REMARKS

In response to the Office Action mailed July 7, 2004, the Applicant respectfully requests reconsideration.

Amendments to the Drawings

Fig 1 (Prior Art)

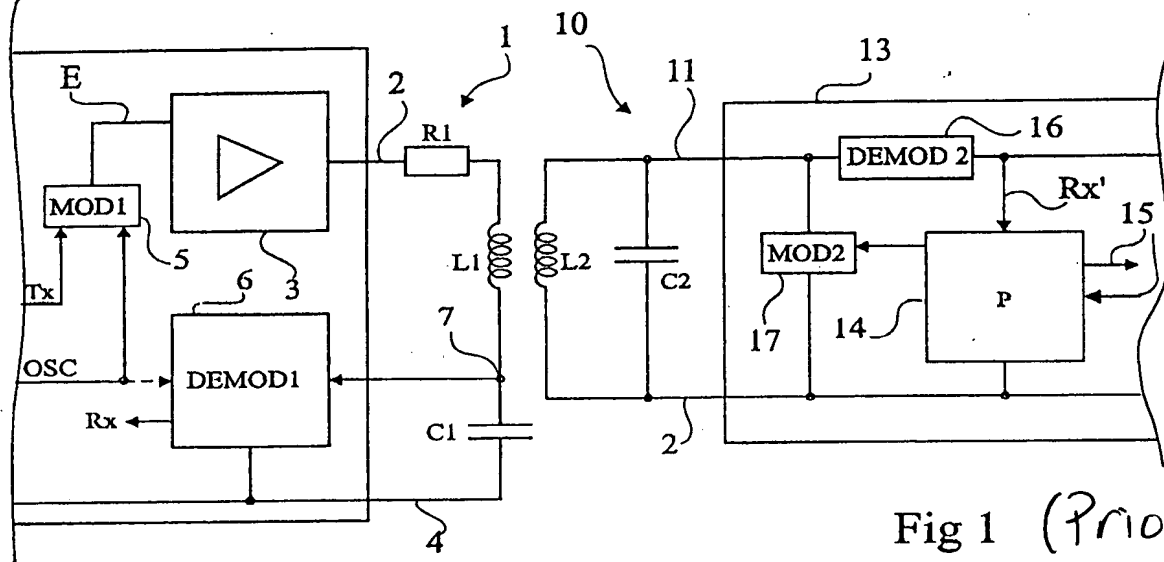
In response to the objection to Fig. 1 (Office Action, page 2), Applicant has amended Fig. 1 by adding the legend "Prior Art," as shown on the corresponding replacement sheets and annotated sheets. Fig. 1 as amended satisfies the requirements of MPEP §608.02(g). Accordingly, Applicant respectfully requests that the objection to Fig. 1 be withdrawn.

Fig 2

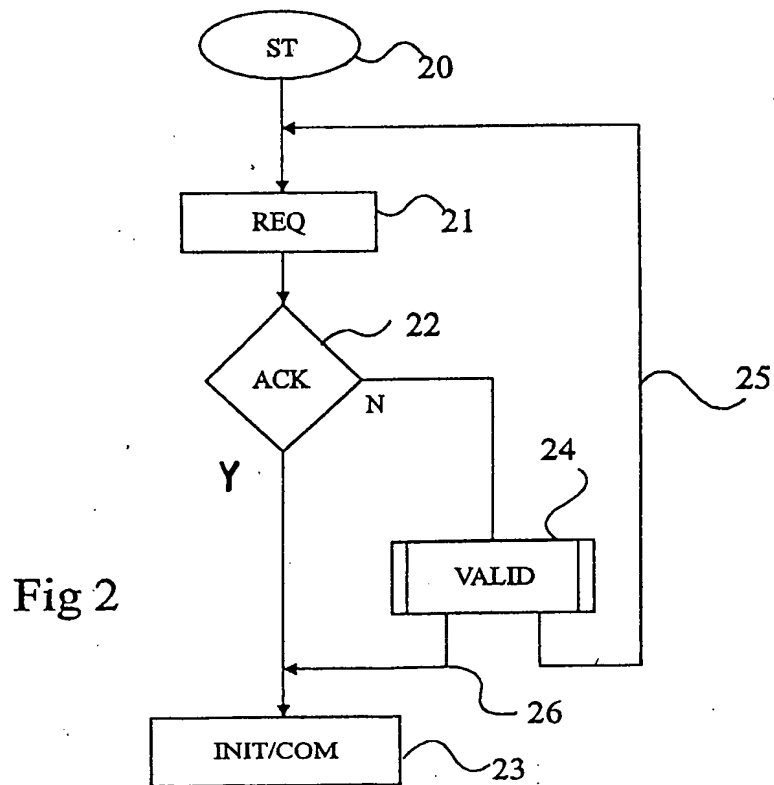
To further the prosecution of this application, amendments have been made to Figs. 2 and 4 as illustrated on the attached replacement sheets and annotated sheets. This application claims priority to a French application. The amendments to Figs. 2 and 4 include changing occurrences of "O" (oui) to "Y" (yes). No new matter has been added by these amendments, and the Examiner is respectfully requested to approve them.
